Office Action Summary

10/782,206

BEN COOPER

DETAILED ACTION

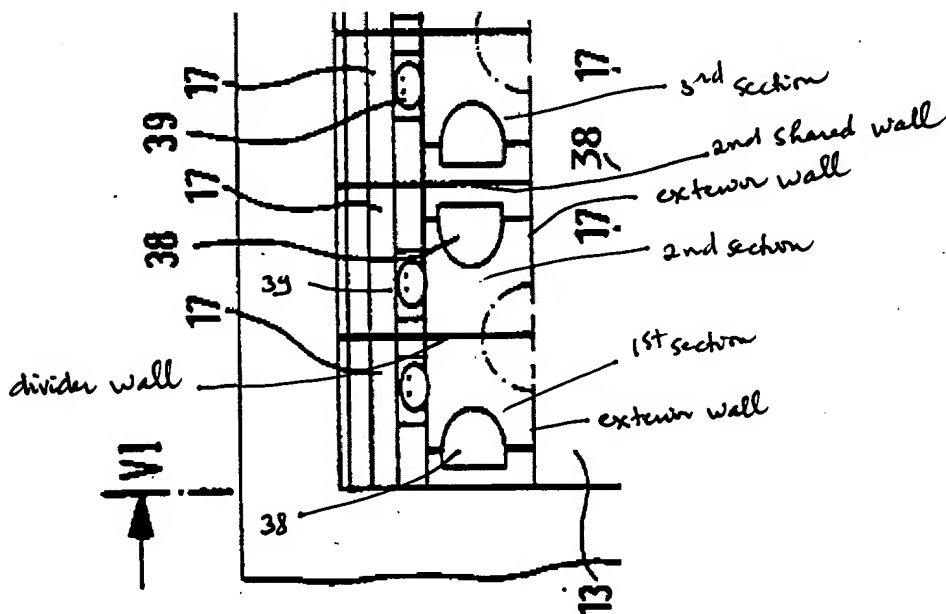
The Schwertfeger et al reference discloses lavatory unit (Fig. 5) comprising a floor 5 (Fig. 6); a ceiling 3 (Fig. 6); a plurality of exterior walls (see a section of Fig. 5 below) coupled to the floor 5 and the ceiling 3, at least two of the exterior walls (the interior side walls near the corridor or waiting area 13 shown in Figs. below) lying in intersecting planes; a first section including a sit-down commode 38 (the 1st toilet area from the bottom in a section of Fig. 5 below); a second section (adjacent to the 1st toilet area) including a sink 39; and a divider wall (as labeled between two toilet areas in a section of Fig. 5 below) for separating the first and second sections, wherein the divider wall includes a planar divider, wherein the planar divider lies in a third plane intersecting both of the intersecting planes.

Regarding claim 2, the first section also includes a sink 39.

Regarding claim 5, a third section (the 3rd toilet area from the bottom of a section of Fig. 5 above) that shares a first shared wall (the ceiling wall 3 in Fig. 6) with a first

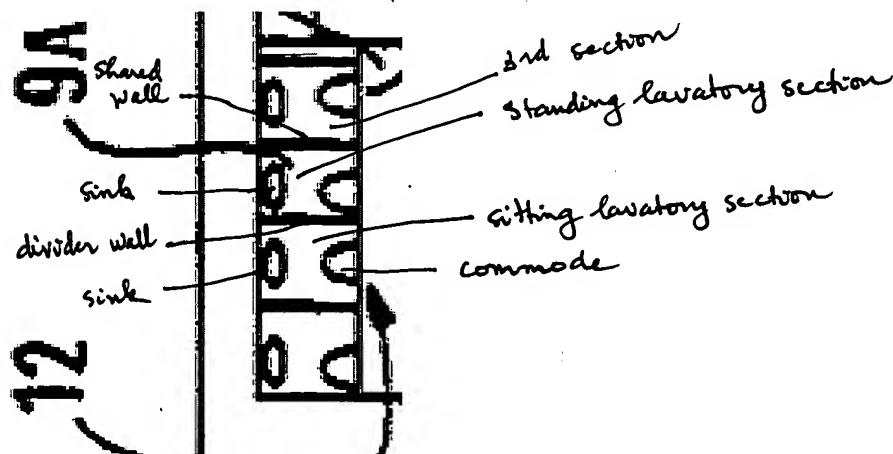
Regarding claim 25, the Schwertfeger et al reference discloses an aircraft (Fig. 2) comprising a fuselage 1, a propulsion system inherently included, a plurality of exterior walls separating the sections of the lavatory unit from other portions of the aircraft (see a section of Fig. 2 below), the plurality of walls defining a footprint of the lavatory unit, a sitting lavatory section including a sit-down commode and partially occupying the footprint (as labeled in a section of Fig. 2 below); and standing lavatory section including at least a sink (as labeled in a section of Fig. 2 below); an adjoining divider wall configured to separate the lavatory unit into the sitting and standing lavatory sections, the divider disposed such that the standing lavatory section (as labeled below) occupies a minority portion of the footprint and the standing lavatory section inaccessible from the sitting lavatory section.

Regarding claim 26, the sitting lavatory section also includes a sink (shown as an oval in Fig. 2).

Regarding claim 29, a third section (as labeled in a section of Fig. 2 above) that shares a wall (the ceiling wall 3 in Fig. 6) with the sitting lavatory section and a wall (the dividing wall between) with the standing lavatory section, wherein the third section is accessible from the outside of the sitting lavatory section and the standing lavatory section.
